PCN # 2023008		Issued Date 11/01/2023	
PCN Title Helios laser eye safety label update.			
Document Version 1.0		Customer Contact Sales@thinklucid.com	
PCN TYPE	<input type="checkbox"/> Electrical Specification <input checked="" type="checkbox"/> Regulatory or Compliance		
	<input type="checkbox"/> Mechanical Specification <input type="checkbox"/> Part Number Change		
	<input type="checkbox"/> Optical Specification <input type="checkbox"/> End of Life		
	<input type="checkbox"/> Firmware Specification <input type="checkbox"/> Other		
Affected Part Number(S)			
PART NUMBER		DESCRIPTION	
HLS003S-001		Helios ToF Ethernet Camera	
HLF003S-001		Helios Flex ToF Ethernet Camera Module	
HLT003S-001		Helios2 IP67 ToF Ethernet Camera	
HTP003S-001		Helios2+ IP67 ToF Ethernet Camera	
HTW003S-001		Helios2 IP67 ToF Ethernet Camera 108X77 FOV

Reason and Description of the Product Change

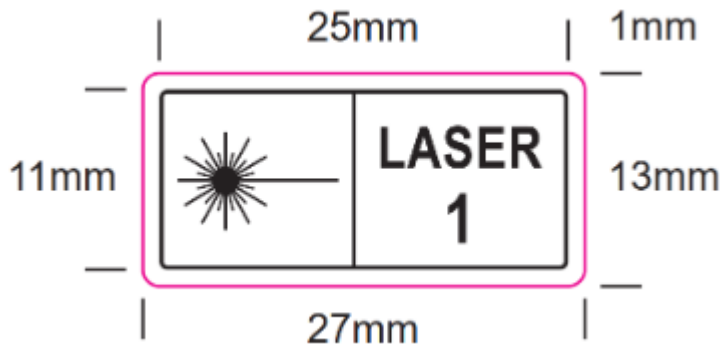
The laser eye safety classification label on our Helios product lines is being updated to have improved accordance with IEC 60825.1 – 2014 standard across multiple regions. The label will be updated for cameras with serial number 233701079 and higher. Please note that no changes have been made to the VECSELS used on the camera or the IEC standard which the camera conforms to, and the change is limited to label only.

Previous laser eye safety label:

Updated laser eye safety label:
